TECHNICAL BULLETIN INDEX
Sorted by Bulletin Number
04/03/86

DATE: May 11, 1983
REVISION DATE: June 20, 1983
BULLETIN NO.: 4:1
PRODUCT: 26-1068/9 Model 4 with 1 or 2 disk drives
SUBASSEMBLY: Model 4 style FDC board Revision blank, Revision A

PURPOSE: To discuss and describe modifications to Model 4 FDC board.

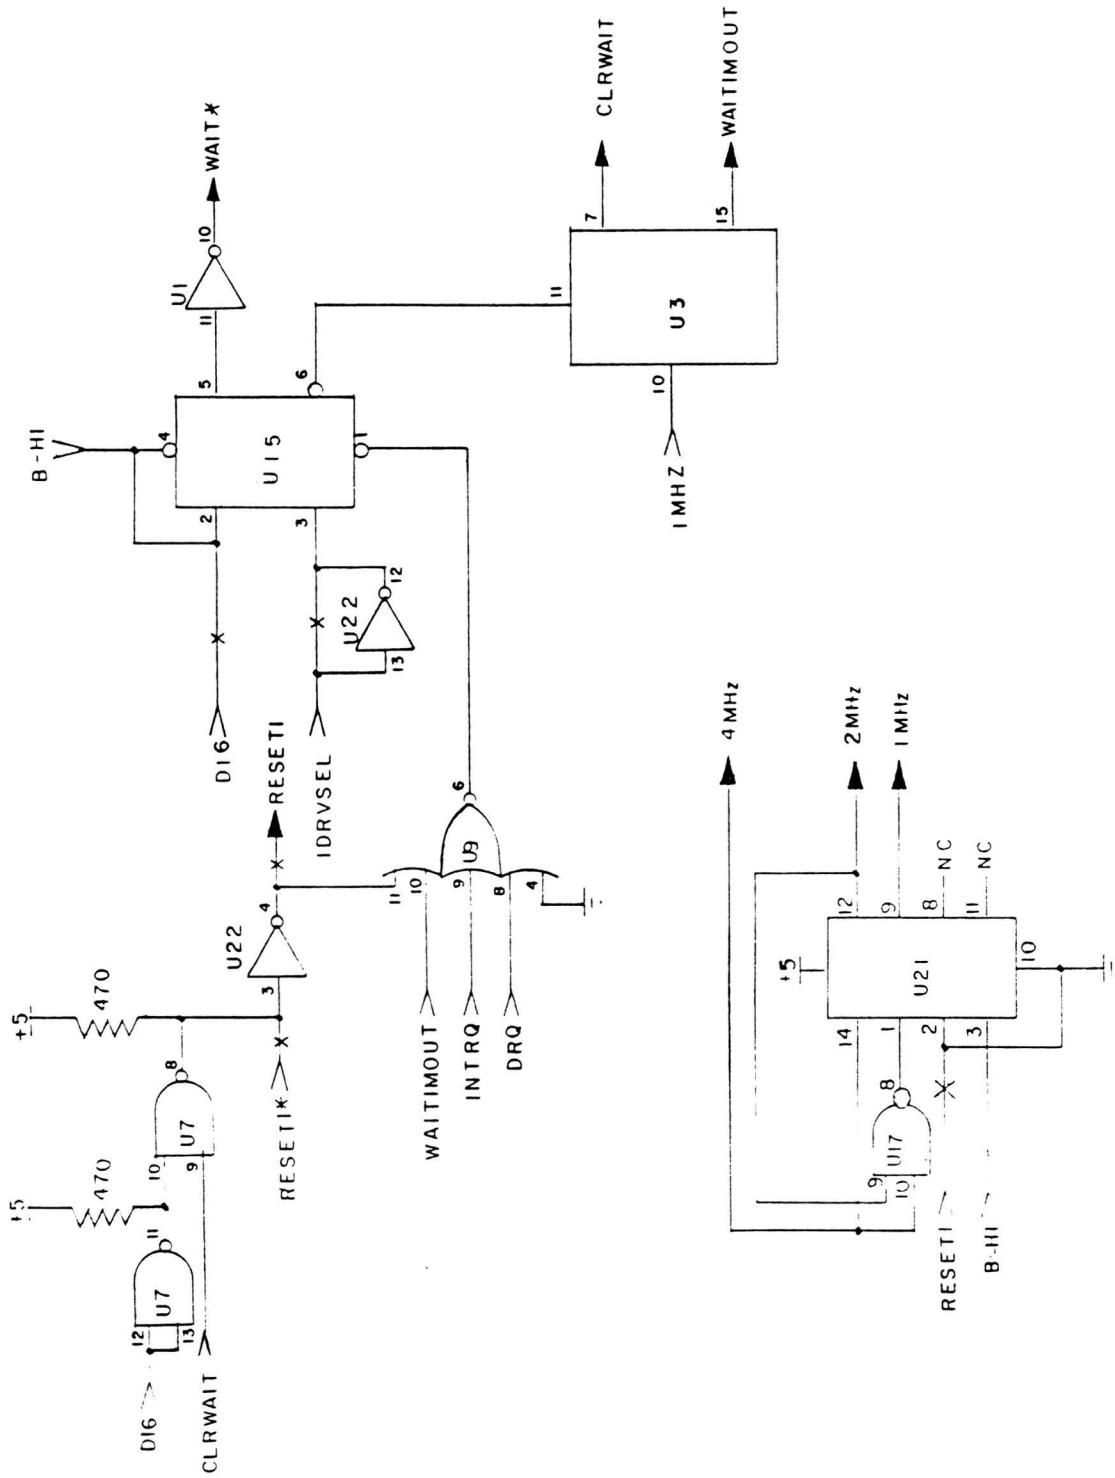
It has been determined that, under certain circumstances, the WAIT state generated by the FDC board will violate the RAS HOLD DOWN specification of the memory ICs.

The problem lies in the timing of the WAIT signal. Unmodified, the WAIT is a function of Bit 6 of port F4H. When this bit is latched (to select the WAIT), the WAIT is not recognized until the next Z-80 opcode fetch cycle. Under this condition the WAIT occurs while RAS is active (LOW).

On the unmodified board the WAIT signal was latched by the trailing edge of the DRVSEL* signal. On the modified board the WAIT is now latched by the leading edge of DRVSEL*. The result is that the WAIT is now recognized during the actual I/O cycle. RAS is not active during this cycle, so even a 1 ms WAIT will not violate the RAS hold down specification. We now need to be concerned only with the REFRESH timing, a problem cured by the 1 ms watchdog timer.

On the modified the board the RESETI line to the U21 is broken. U21 is always active, and the FDC board always becomes ready in time.

- 1) Cut the trace leaving U15 pin 3. Cut the trace close to pin 3.

- 1) Cut the trace leaving U15 pin 2. Cut the trace between pin 2 and the first feedthrough.
- 2) Cut U22 pin 3 at the LEFT MOST trace running between U22 and U17.

- 1) U21 pin 2. Use the small dykes and cut the pin loose from the PCB. DO NOT cut the pin loose from the IC. Bend the pin upwards so you can solder to it later.

Get the two 47 Ω ohm resistors you were asked to obtain earlier. Cut each lead on each resistor to approximately 3/8 inch in length. Bend the resistors into a "U" shape. Install the resistors as follows:

- 1) One resistor from U7 pin 14 to U7 pins 10 and 11. Place the resistor lead between pins 10 and 11 and solder the two pins and the resistor lead together.
- 2) One resistor from U7 pin 8 to U12 pin 14.

- 1) U3 pin 7 to U7 pin 9.
- 2) U7 pin 12 to U7 pin 13 to U12 pin 12. Note that U7 pins 12 and 13 are close together and can be connected by one end of the jumper to U12 pin 12.
- 3) U15 pin 2 to U15 pin 4.
- 4) U15 pin 3 to U22 pin 12.
- 5) U15 pin 11 to U22 pin 13.
- 6) U21 pin 2 (the bent up pin) to U21 pin 10.
- 7) U7 pin 8 (with the resistor lead) to U22 pin 3.

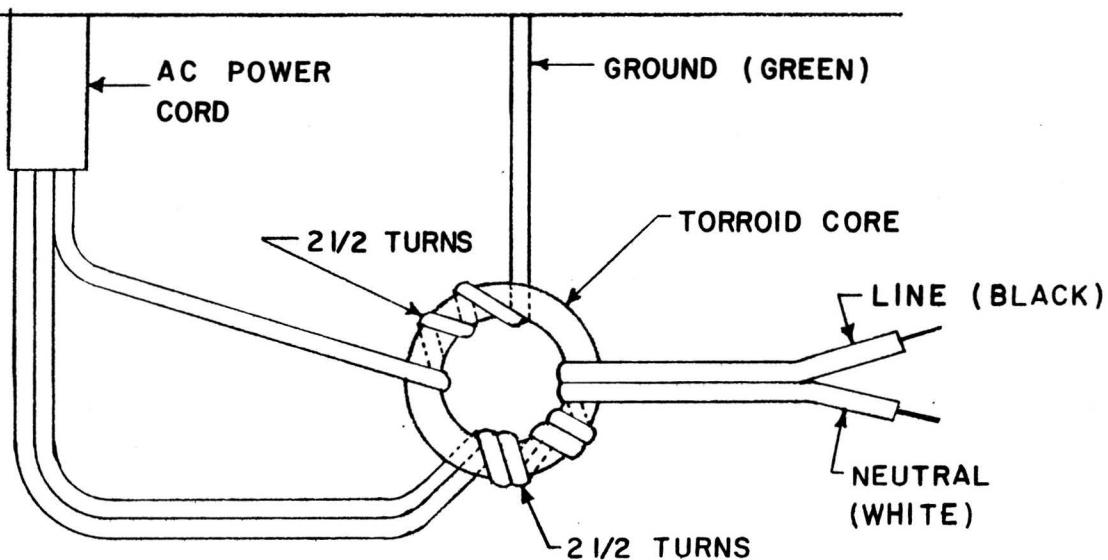
For proper RFI suppression, the ferrite toroid supplied with the Model III to Model 4 upgrade needs to be wrapped correctly. The correct procedure is to wrap the AC wires 2 1/2 turns in one direction and the ground wire 2 1/2 turns in the opposite direction.

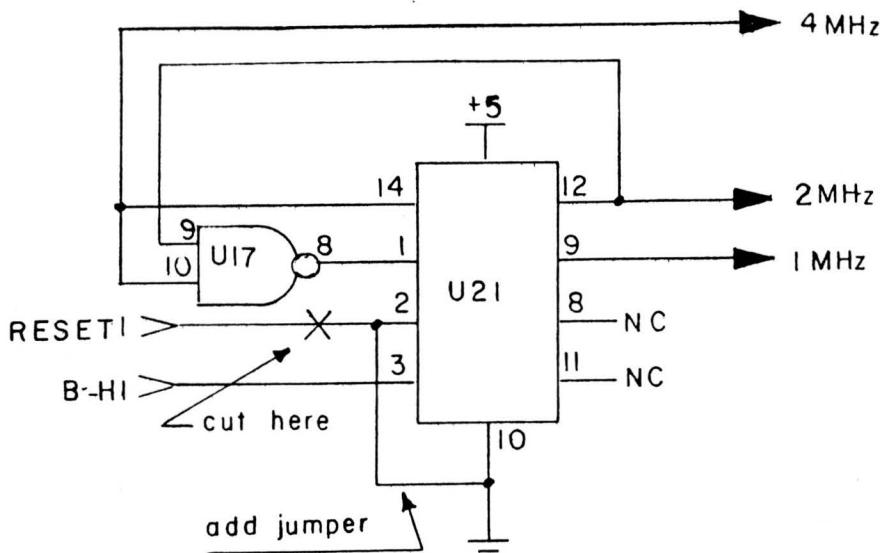
Under the right conditions the FDC chip will not become ready by the time the CPU checks the FDC port. If this happens the CPU will assume that no FDC is attached, and jump directly into Cassette BASIC (CASS?).

To prevent this problem, the clock must be permanently enabled.

Cut U21 pin 2. Using the small cutters, cut the pin loose from the PCB. DO NOT cut the pin from the IC. Bend the pin up and away from the PCB so that you can solder to it later.

U21 pin 2 (the bent up pin) to U21 pin 10

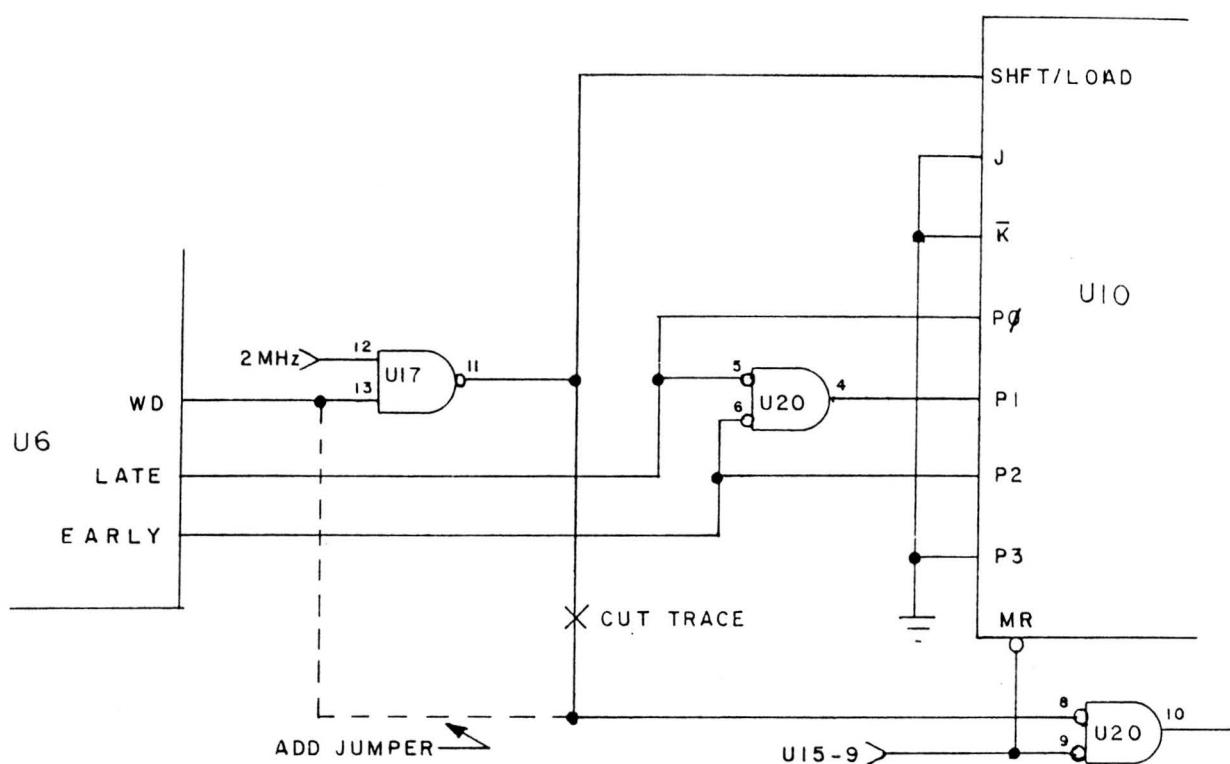
PURPOSE: FDC won't write in single density mode

- 1) Cut pin 8 of U20 loose from the PCB. **DO NOT cut the pin away from the IC.** Bend the pin up to solder to later.

- 1) Jumper U20 pin 8 to U17 pin 13

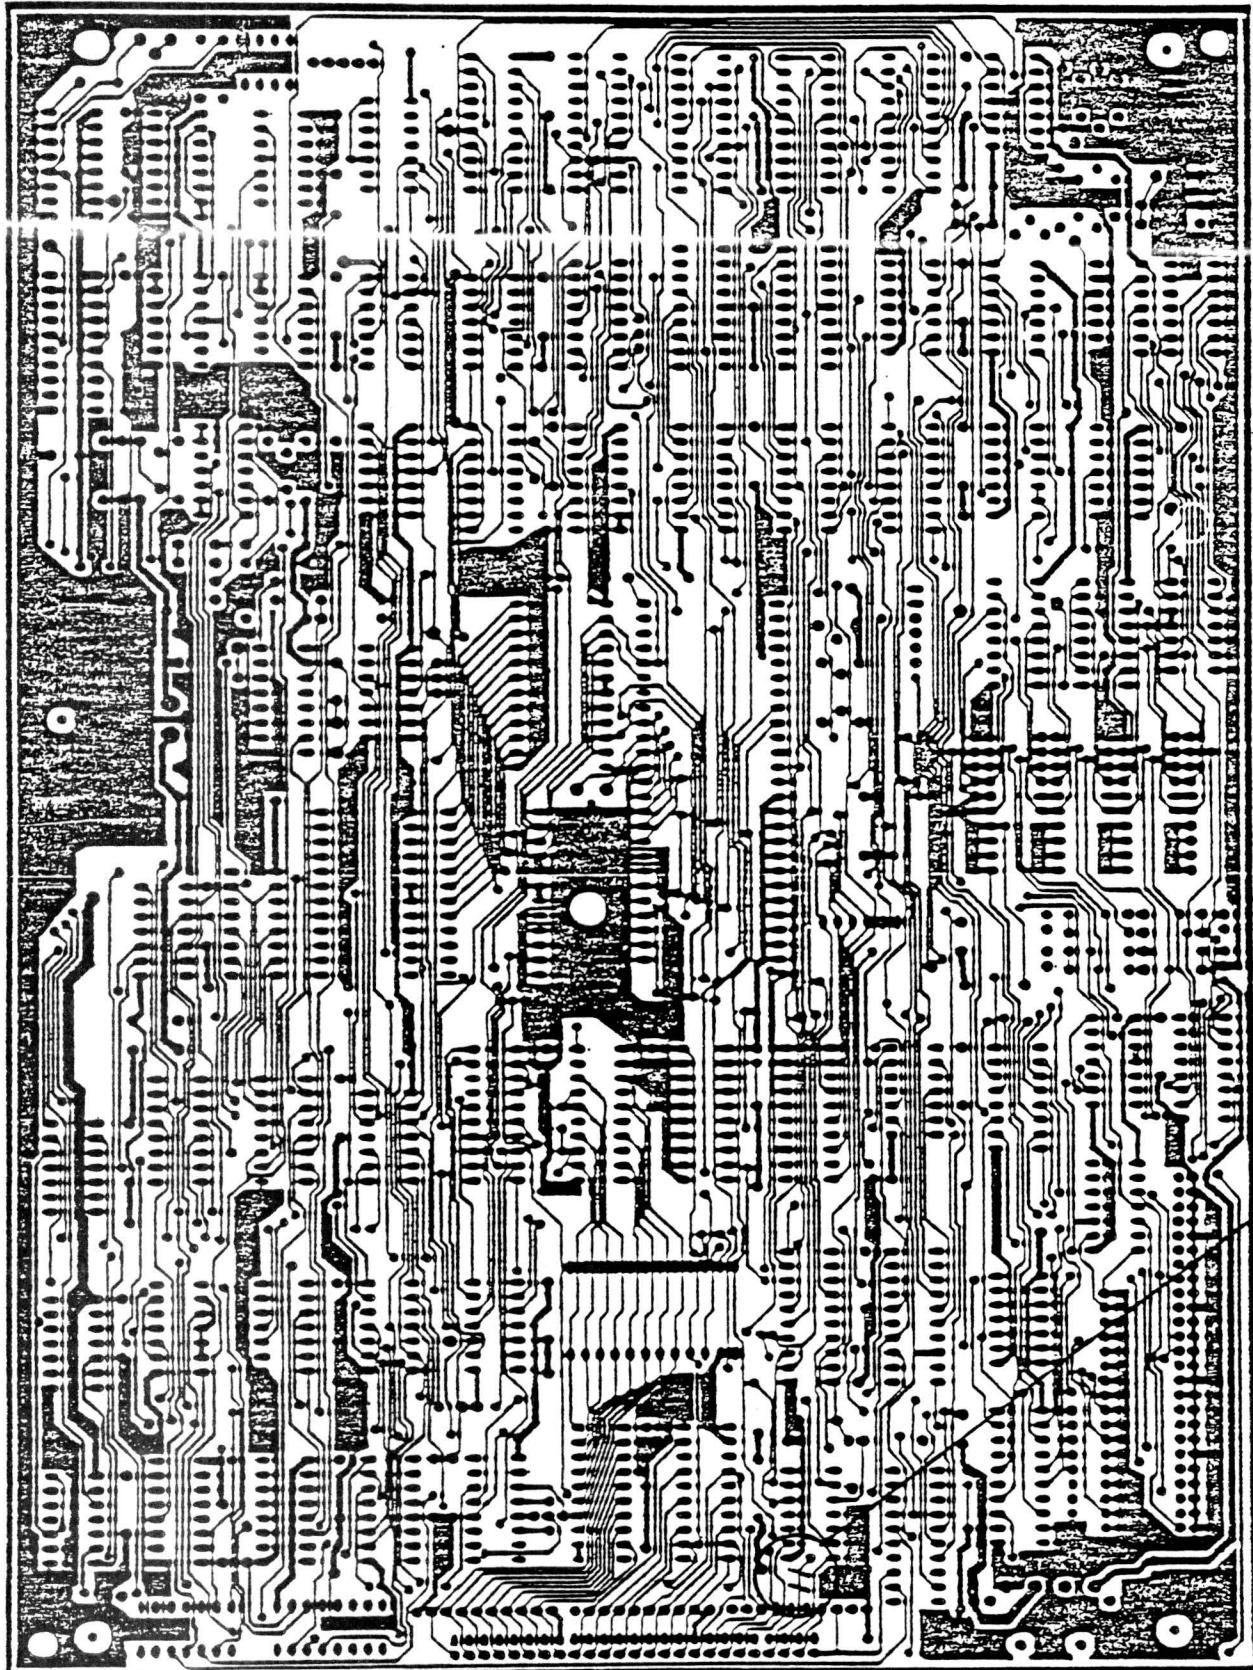
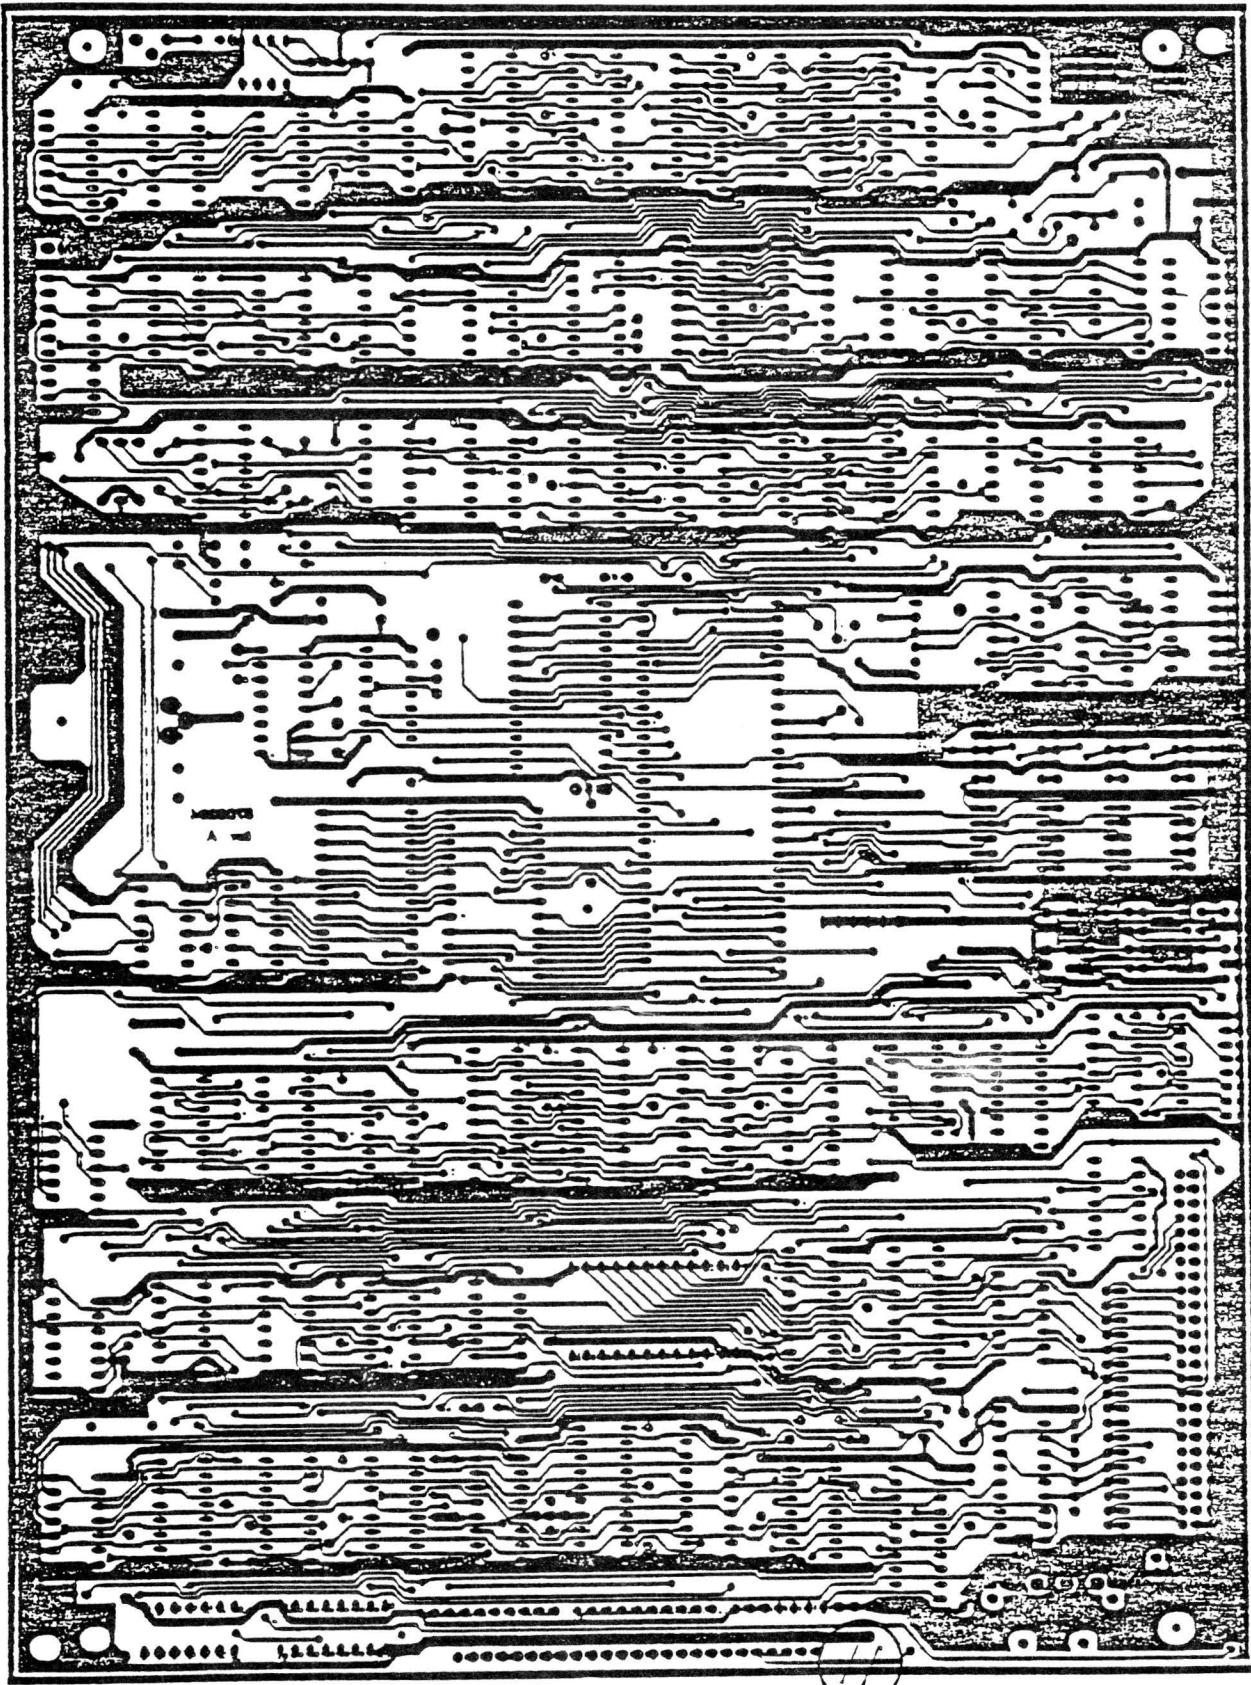
A loading problem exists when the 5-Megabyte Hard Drive is connected to the Model 4 I/O Bus connector. This problem can cause a foldback condition in the power supply until enough current is available to drive the lines to and from the Hard Drive.

This loading problem can be cured by supplying open collector drivers on the Hard Drive Controller PCB inside the Hard Drive. These drivers connect to the EXTIOSEL* and XIOBUSWAIT* input lines on the Model 4 I/O Bus.

Cut the trace going from J7 pin 41 to U73 pin 5.

Cut the trace going from J7 pin 43 to U73 pin 7.

- 1) Jumper U38 pin 11 to U72 pin 1
- 2) Jumper U72 pin 2 to J7 pin 41
- 3) Jumper U58 pin 10 to U72 pin 3
- 4) Jumper U72 pin 4 to J7 pin 43
